APPLICATION No. H/16/0517/93

Planning Permission

Description: Proposed bungalow with detached garage

Location : Plot 2, Beechfield Gardens Spalding Lincs

SITE LAYOUT

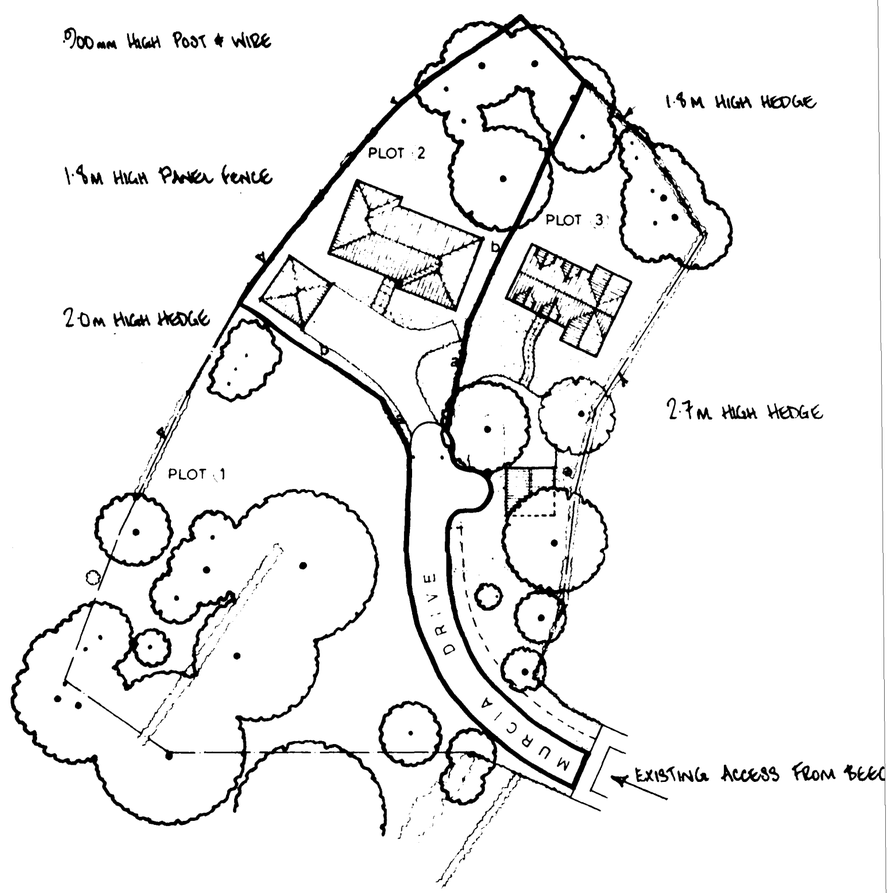
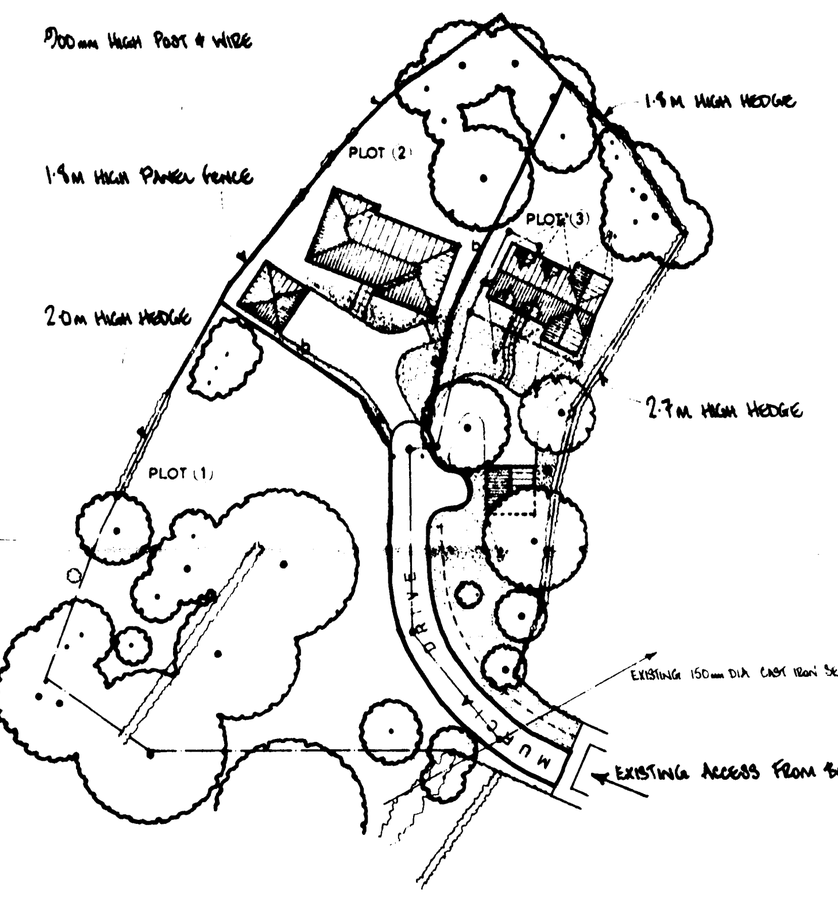
Site seems bigger than plan shows. need not/shouldn't be shaded by canopy of tree
1.8m fence, Leylandii (new) + Post fraxinus to Cleyhall Drive

4 The applicants have been advised of the requirements of the Consultant Arboriculturalist and amended plans have been received. However, the alterations to Plot 2 do not appear satisfactory. It is considered, however, that the two proposals will be satisfactory after further amendment to Plot 2 and subject to a landscaping scheme being submitted. This scheme should use tree species which continue the existing tree population forward into the future, rather than using small trees normally used on residential estates.

The dwelling should be repositioned so that it is at least 3 metres further away from the Weeping Beech tree. In addition the four trees to the south east of the site require some attention. According to the advice that I have received one of these trees is dead and should be removed and a Beech tree that leans could also be removed. The other two trees which are a Beech and an Ash should be pruned to remove all the wood in their crowns. I therefore advise that you contact Miss D Fairchild in order to have this work done. However, although the Local Planning Authority have been advised that the Beech tree which leans could be removed I do not guarantee that this will be permitted.

eech on this plot. The dwelling therefore needs to be sited at least 4 metres further away from the tree by moving the property to the north west. The tree is also growing on a slightly raised area and the Local Planning Authority have been advised that a small retaining wall should be built around the tree so that the existing ground level can be maintained.

Amendment: Move bungalow forward (drawing number 93021)
